January 19, 2023

Re: Evaluation of the Roseau Lake Rehabilitation Study and the hydrologic and hydraulic modeling used in the study

Figure 1. Storage Area Stage Hydrographs

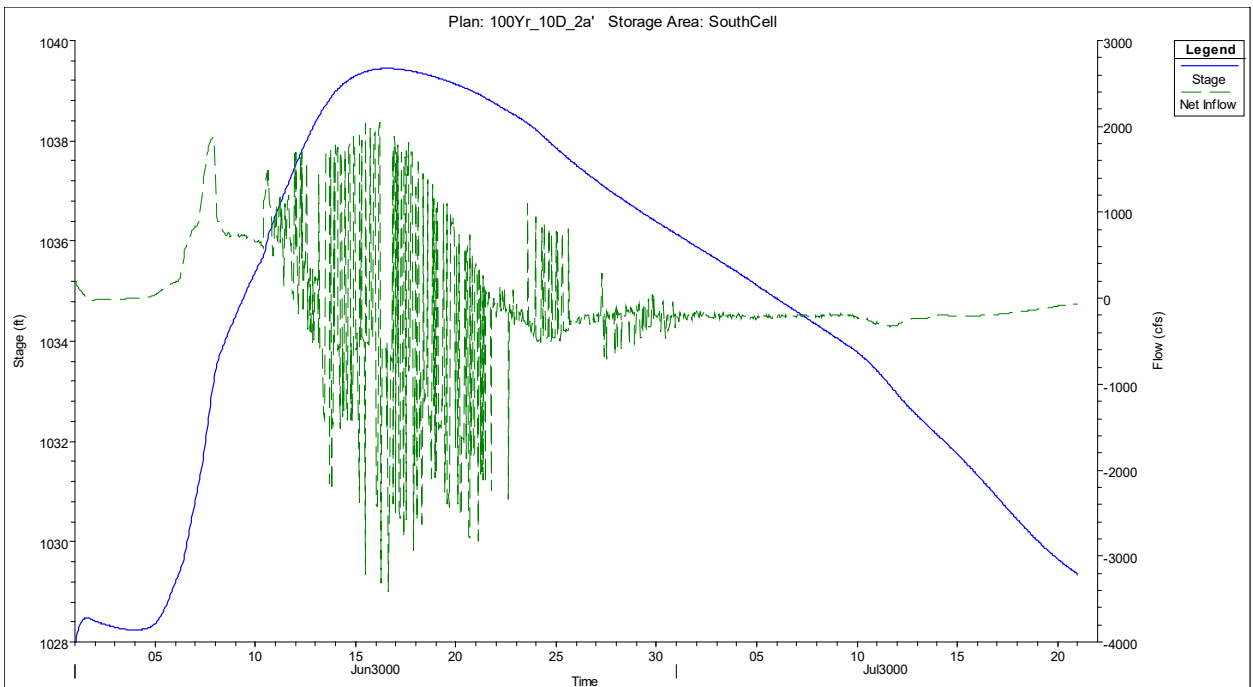
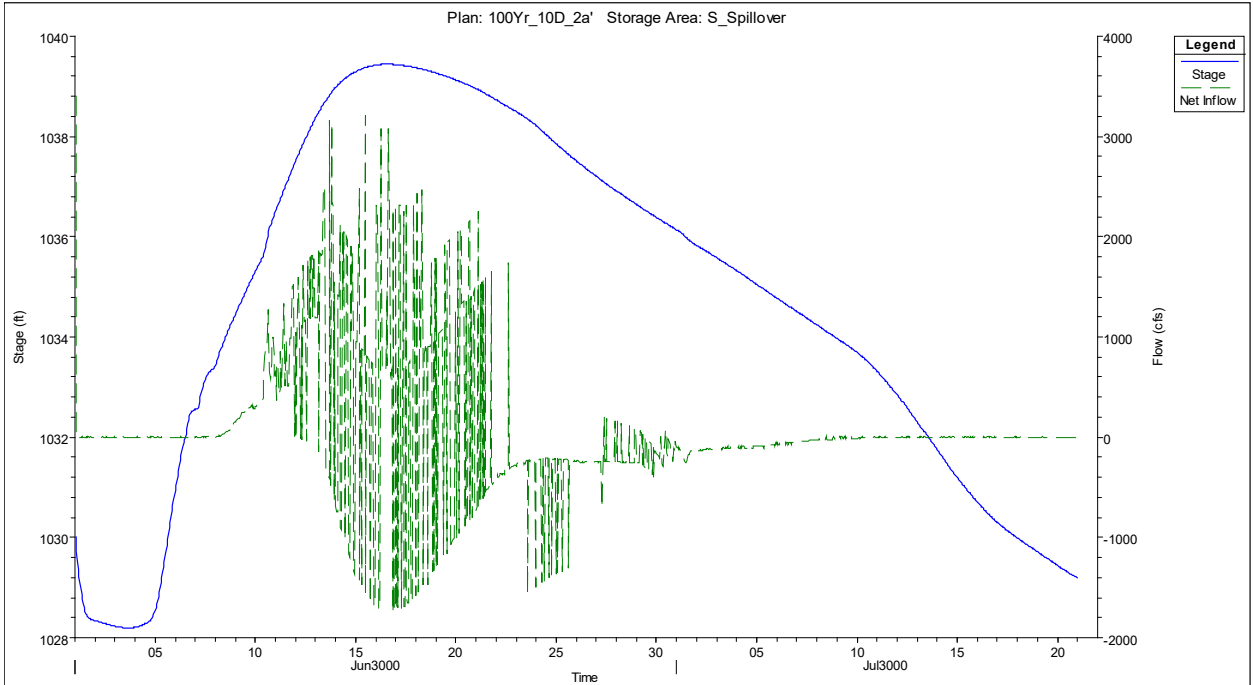
Model flow instabilities were observed when reviewing the stage-flow hydrographs for some storage areas and storage area connections. Figure 1 shows two of such storage areas. As seen in Figure 1, the discharges indicated by the flow hydrographs for the S_Spillover and SouthCell storage areas fluctuate rapidly for a period of over 10 days. For example, in the case of the S_Spillover storage area the flow fluctuates from about 3160 cfs to about minus 480 cfs and then back to about 3100 cfs over the period of two hours which is not expected to be representative of real conditions during a flood. The fluctuations are similarly evident in Figure 2 which shows the storage area connections S Embankment 1 and NW Embankment 2. It is not possible to estimate the impact the model instability may be having on overall model output.

Given the concern of the community and the impacts that even a very small increase in water level may have on the residents, farm land and infrastructure in the area, this possible discrepancy should be reviewed, and if the input data is in error, the model should be corrected, and the modeling and evaluation of the model results redone. In addition, the reach conveyance ratios and cross-section extents should be evaluated to minimize errors associated with the model run results, and the results be provided in an updated report.

Figure 3. Plan View Storage Areas

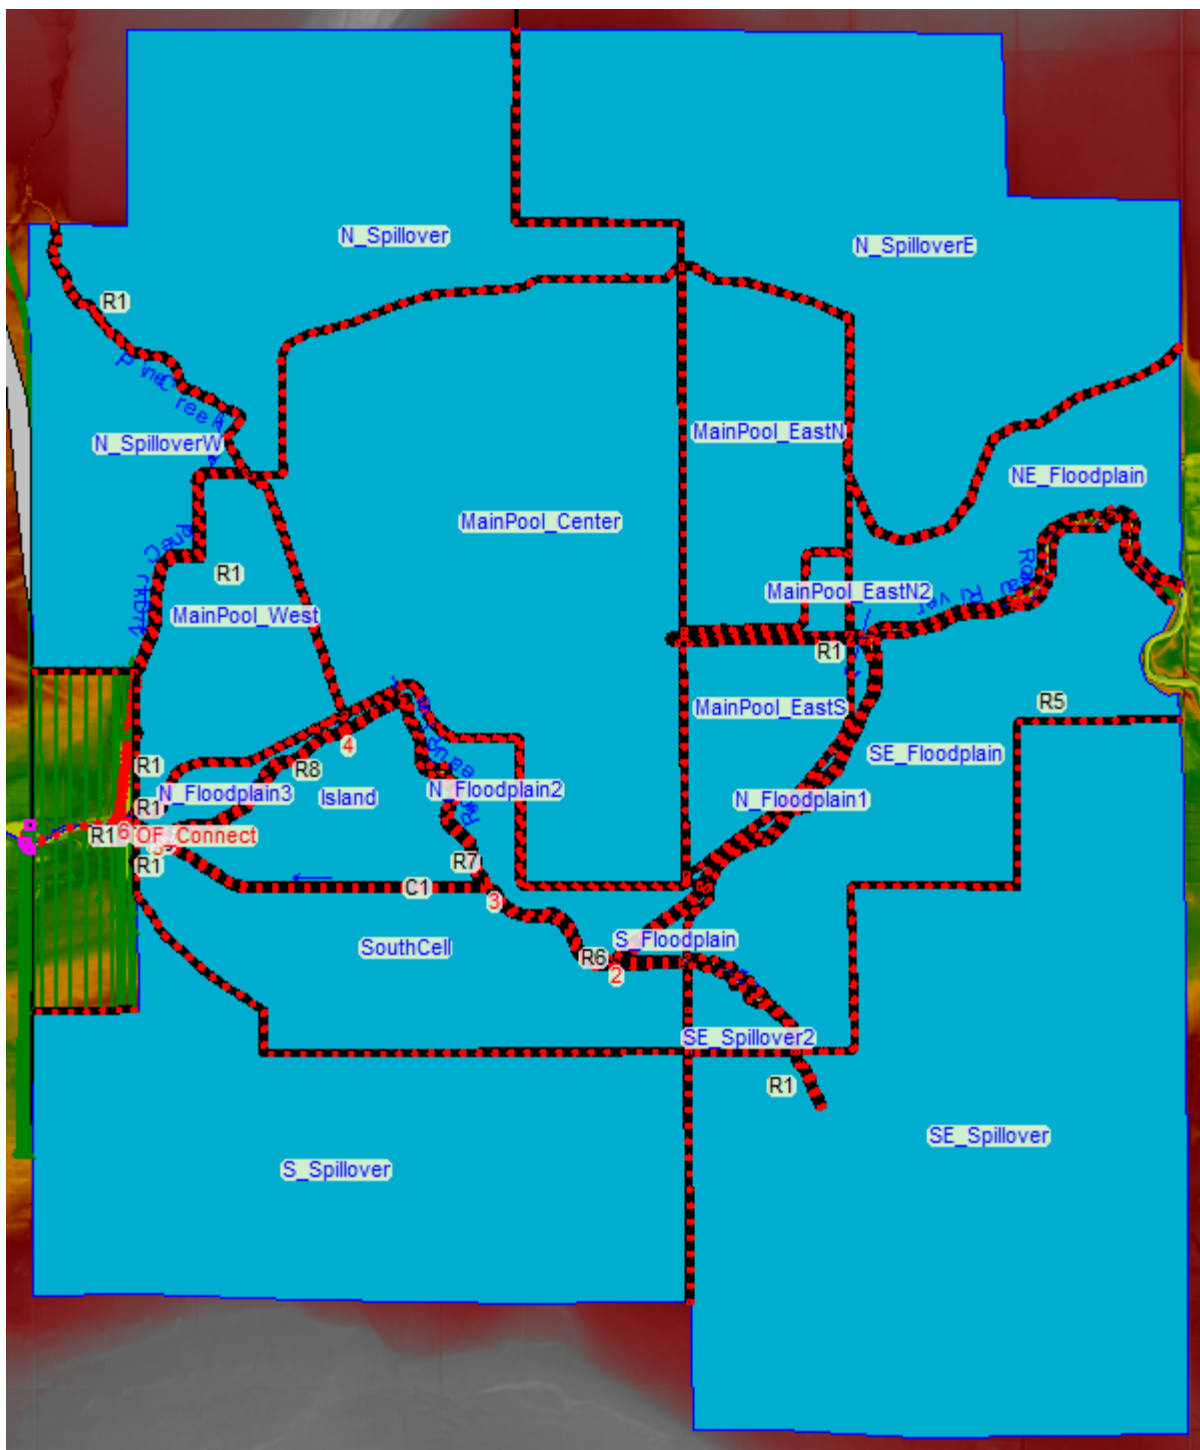
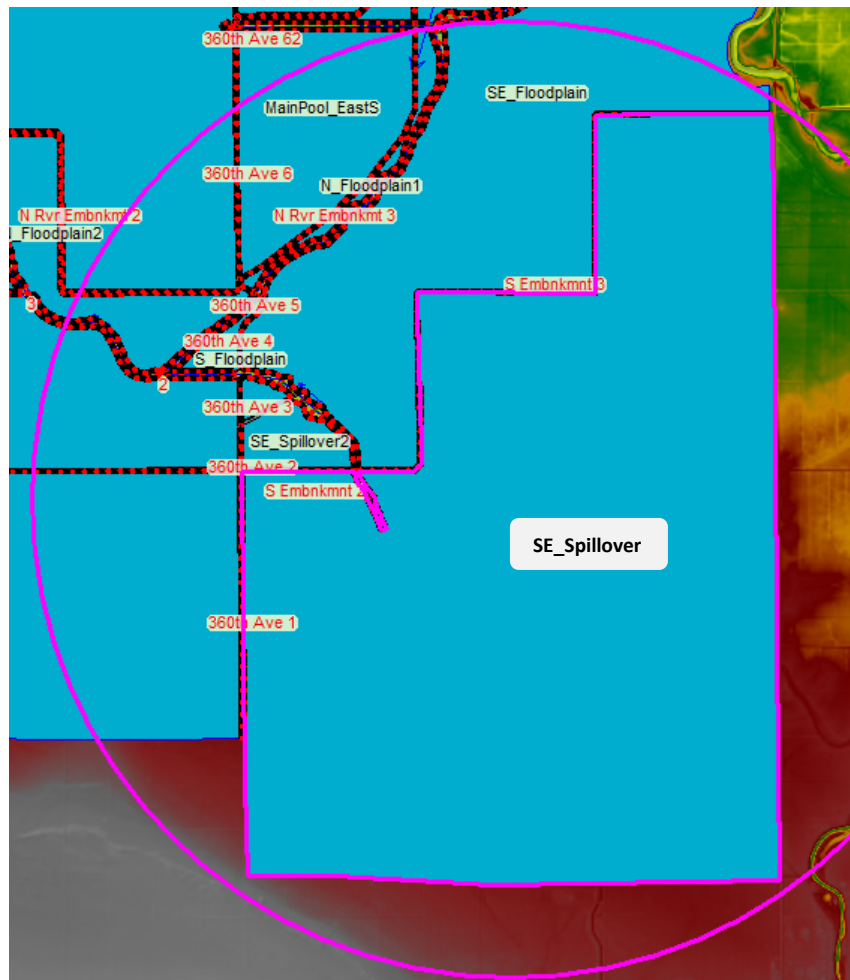
The review also indicates that the selection of model parameters is reasonable. However, during the review it was noted that input parameters for one of the storage areas appears to be incorrect. The SE_Spillover2 elevation-storage volume input data appears to have been copied from the SE_Spillover storage data, and not changed to the correct area-storage curve. Figures 3 and 4 show the two areas and Table 1 shows the elevation-storage table for the two sub-basins used in the modeling. Table 2 summarizes the surface area of the Roseau River storage areas at the peak of the 100-yr 10-day flood. As seen in Figures 3 and 4, from the plan view, the storage areas SE_Spillover and SE_Spillover2 have widely differing surface areas, whereas the respective input storage volumes in the model are the same for both. This discrepancy needs clarification. Not having the topographic survey information makes the precise determination of the impact of this apparent discrepancy not possible as part of this review. None-the-less as is visually evident from Figures 3 and 4, and also noted in Tables 1 and 2, the impact of this discrepancy could be quite significant and lead to model results that do not accurately represent present or proposed conditions.

As presently modeled, the surface areas of the SE Spillover and SE Spillover2 storage areas each contribute nominally 13% of the overall combined surface area of the 19 storage areas during the 100-year 10-day flood event. In combination, they account for over 25 percent for the surface area of the 19 storage areas. It visually appears that the surface area of the SE Spillover2 storage area is actually less than 5 percent of the SE Spillover area. Even assuming the SE Spillover2 area to be 10%

that of the SE Spillover sub-basin, if this is the case, there would be a reduction of the surface area of these two combined storage areas to approximately 15% of the overall storage area, and a corresponding reduction of the total surface area of all 19 storage areas by approximately 10 percent. Given the size of the differences, the impacts of this discrepancy could be quite significant.
